**RFB-2022-42**  
**SCCC CHEMISTRY LAB RENOVATION**

**ADDENDUM #2**

Issued Date 3/2/2022

Title: Floor Plan

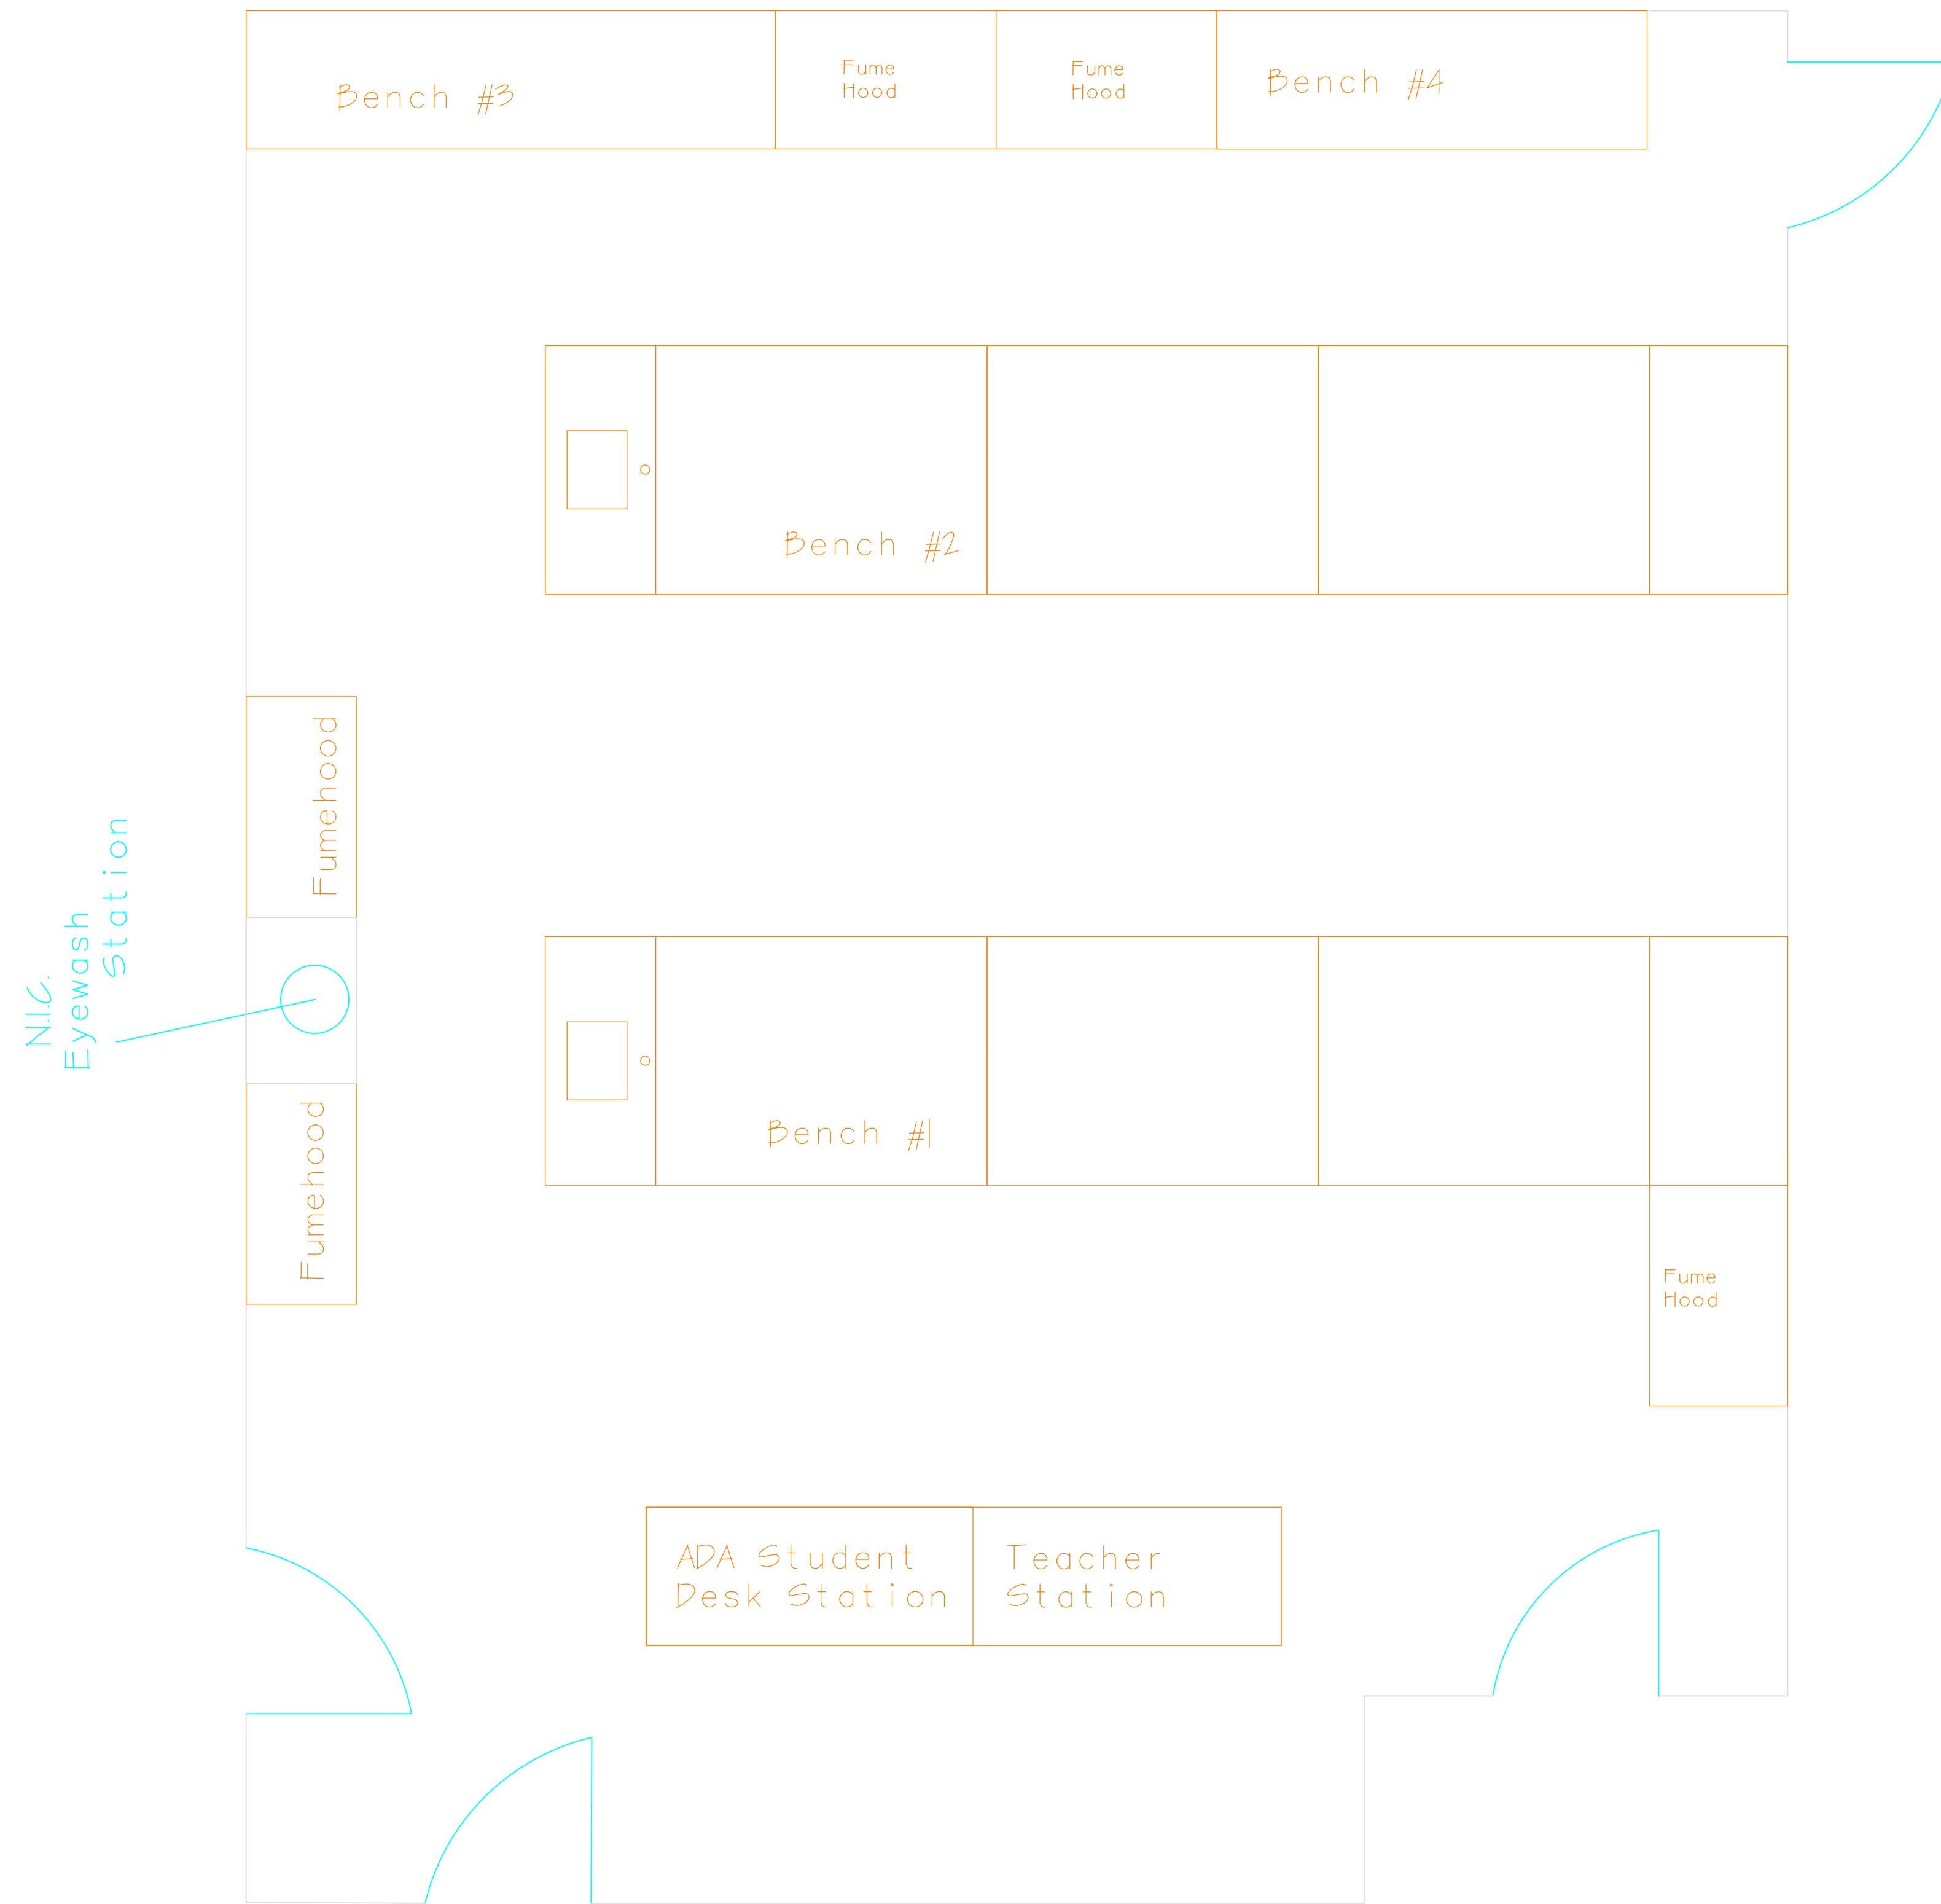
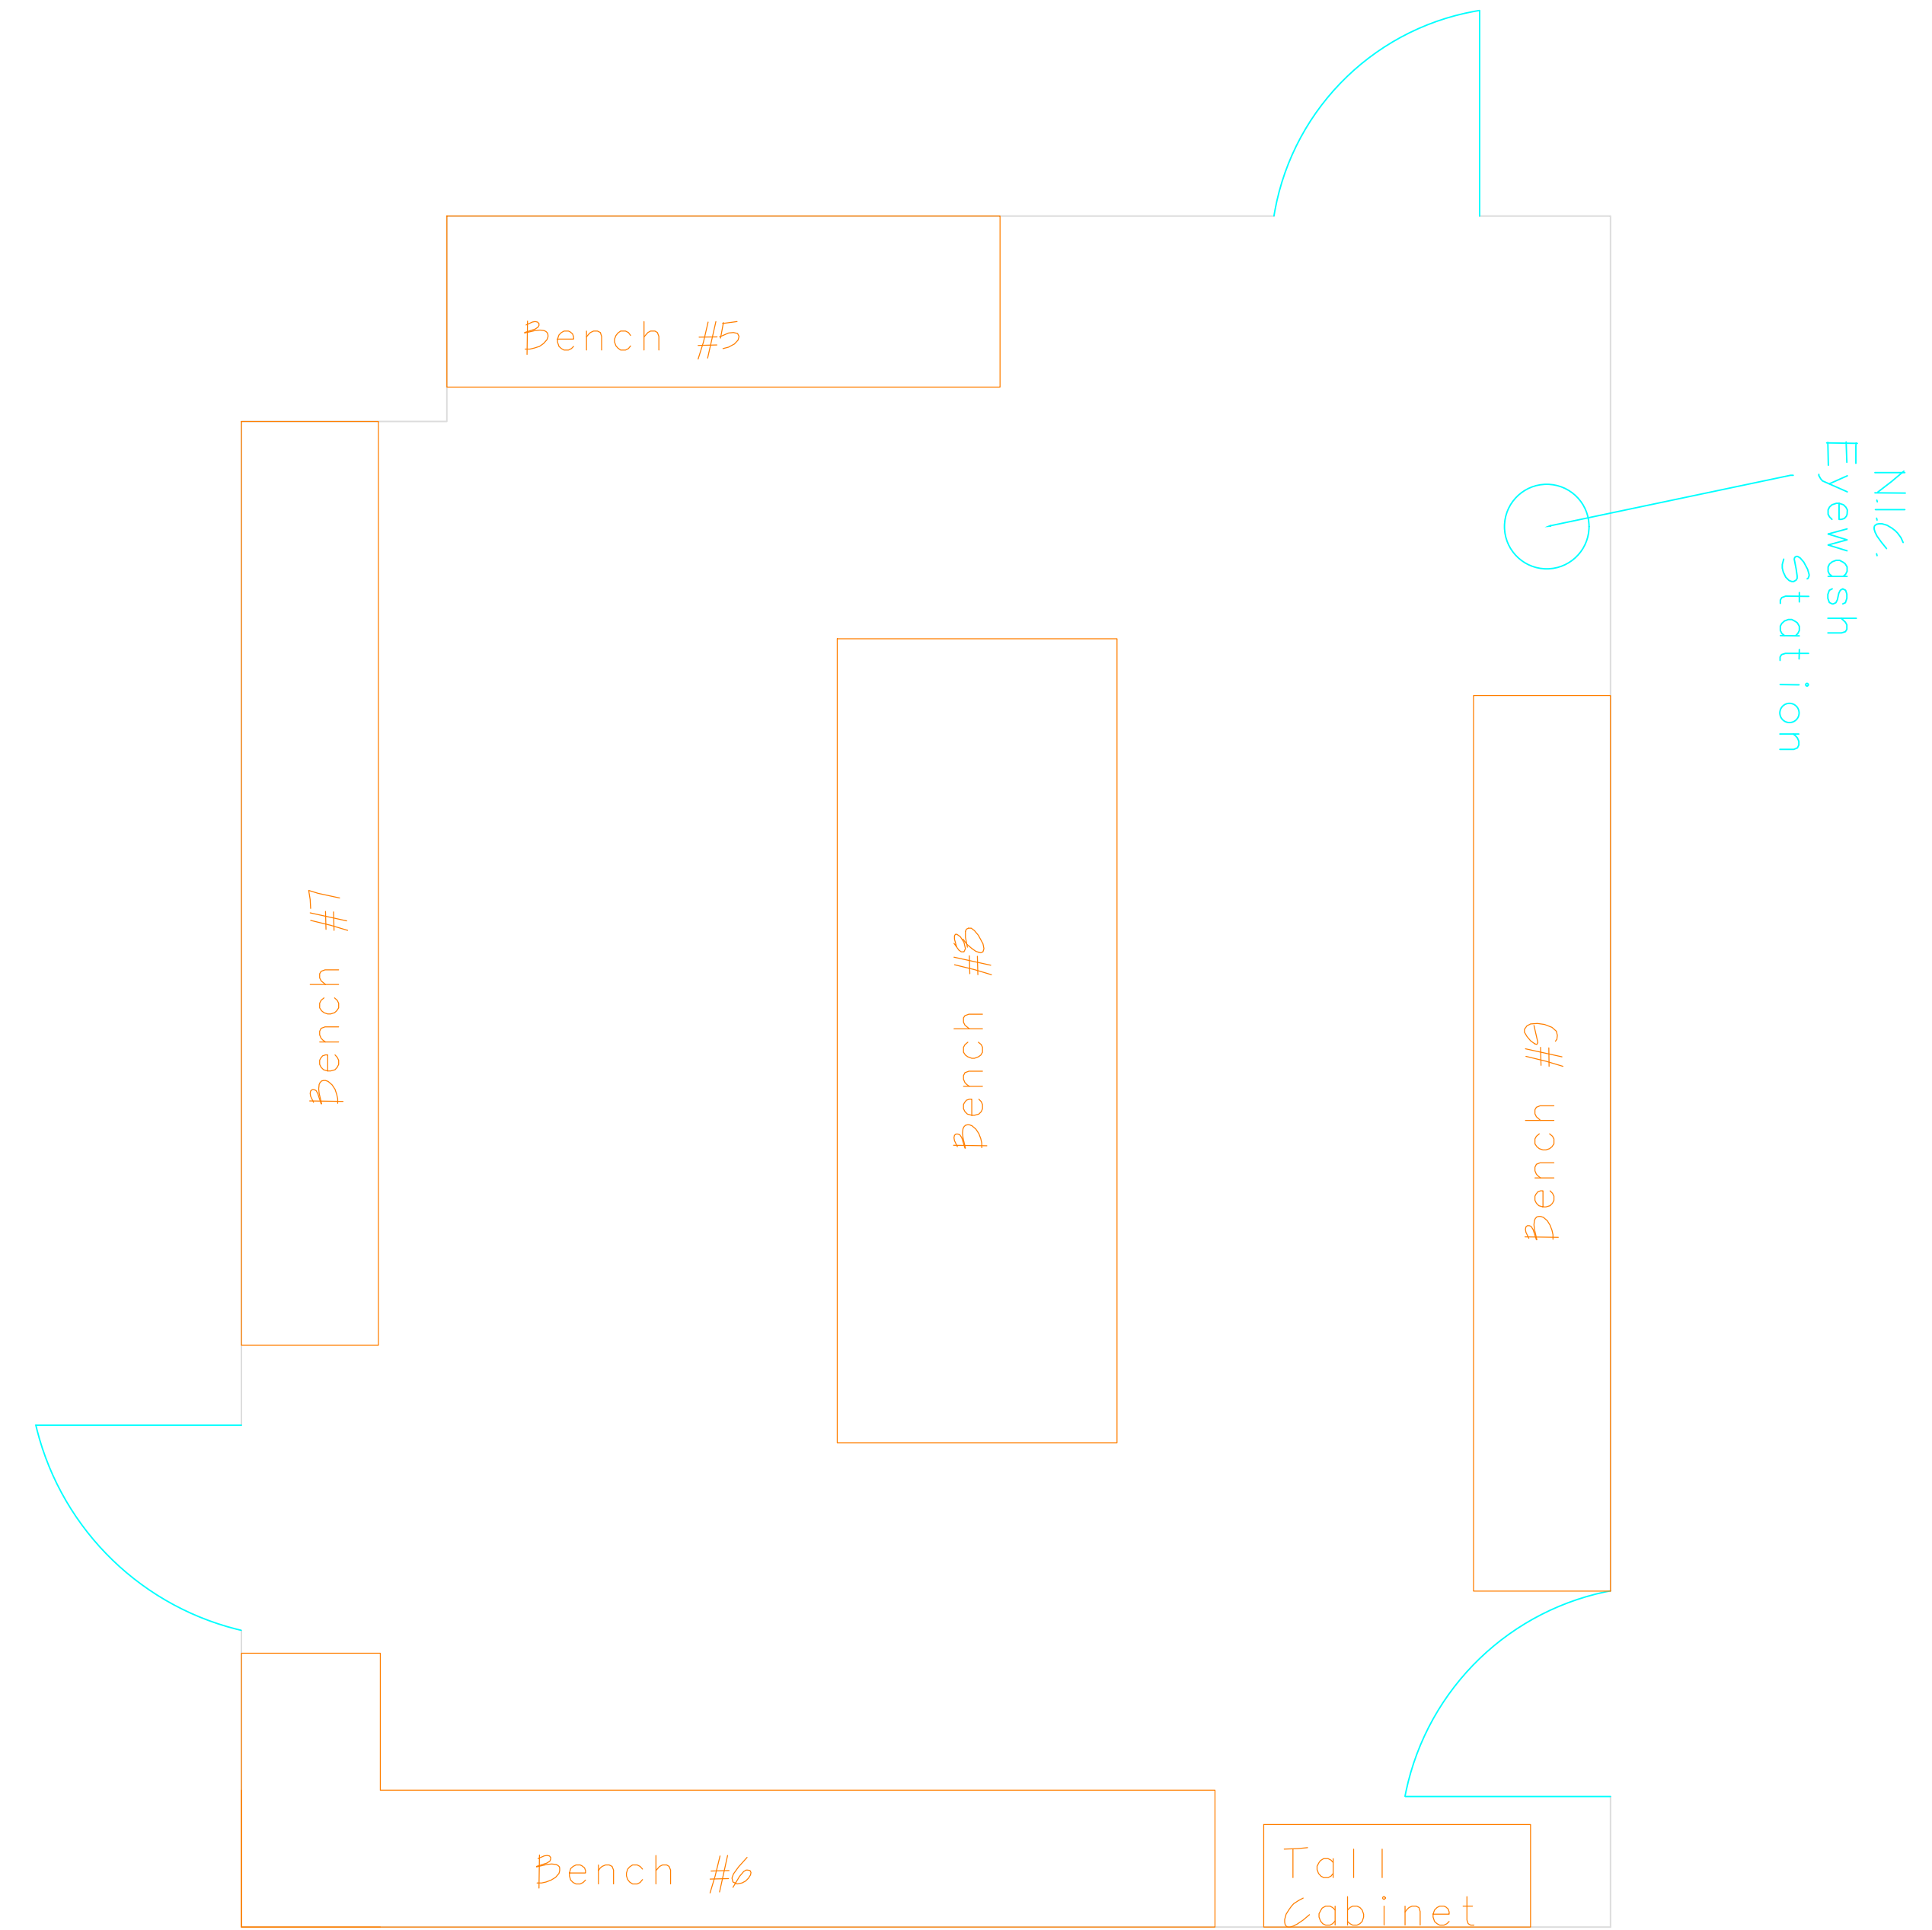
Answer: [Only Instrument Room. Please eliminate drawing E-1 and see revised attached drawings.](#)
  7. If so, areas to quote in Instrument Room only show the island, that’s the only item on the plan view. However in A-2 Cabinet details Prep Room shows 3 cabinets on exterior walls... East, South, West.

Answer: [Please see revised drawings attached to this addenda.](#)
  8. What cabinets need to be quoted for Prep Room & Instrument Room, and can cabinet typical be provided for all cabinets needing a quote for these rooms.

Answer: [Please see revised drawings attached to this addenda.](#)
  9. A-2 Cabinet details is a 1 of 1 drawing showing the elevations and dimension of “cabinet typicals” for Prep Room and Instructors Accessible Station Cabinets. No cabinet typical details were provided for Chem Lab Room 202, Chem Lab-A-1 is an additional drawing (1 of 1) provided, but only provides an overhead view of the Chem Lab Room 202 bench dimensions. Can a drawing be provided of what is needed for an actual “cabinet typicals” requested for Chem Lab 202?
